Office Action Summary

10/697,225

DAVIS ET AL.

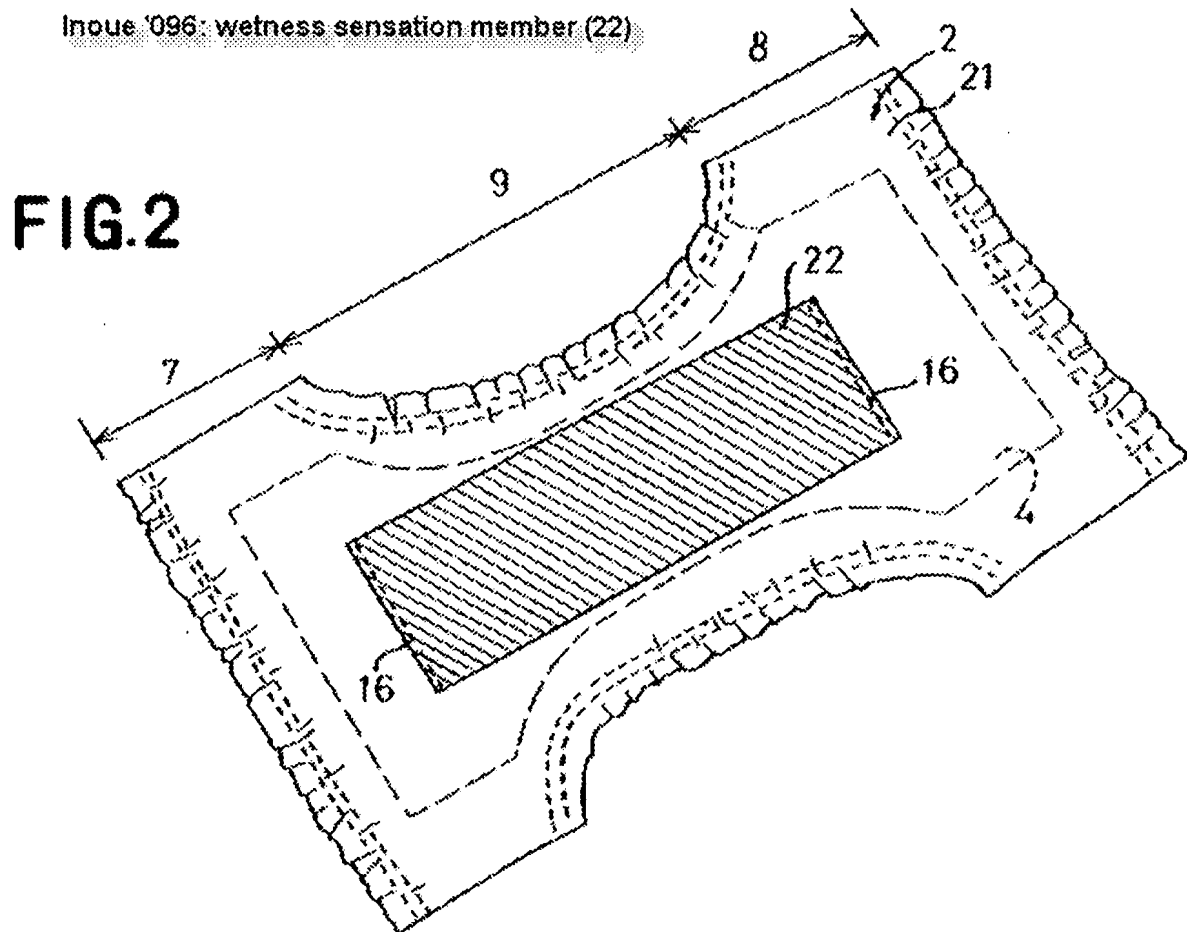
As seen in Figures 2 and 3, Inoue teaches a toilet training diaper comprising a wetness sensation member (22) integrated with the topsheet (2). As best depicted in Figures 2 and 3, for purposes of illustration Figure 2 is reproduced below, because the wetness sensation member is a smaller piece of material located on top of the flow control layer (21) and further comprises a different material having different properties and characteristics (c. 2, ll. 30-67 to c. 3, ll. 1-10), the examiner has a reasonable basis to conclude that the wetness sensation member (22) would

differ in appearance and therefore would be noticeable from its surroundings, *e.g.*, by differing in coloration, hue, or tint, by differing in lightness, darkness, or contrast, by differing due to the presence or absence of solid color forms, or by any other variation serving to create noticeable visible differentiation, and would be substantially unchanged upon wetting. Additionally, Inoue teaches at c. 3, ll. 58-59 that there is a level difference between the layers, i.e. the wetness sensation member layer (22) is raised or in relief above the flow control layer (21).

Thus the wetness sensation layer of Inoue meets the definition of visible highlighting as set forth by Applicants and therefore fulfills the claim limitations. Therefore, it would have been obvious to one having ordinary skill in the art at the time the invention was made to form the wetness sensation member of Iguae visibly highlighted as taught by Inoue in order to provide a noticeable wetness sensation member for toilet training since it has been held to be within the general skill of a worker in the art to select a known material on the basis of its suitability, here, appearance, as a matter of obvious design choice. *In re Leshin*, 125 USPQ 416.
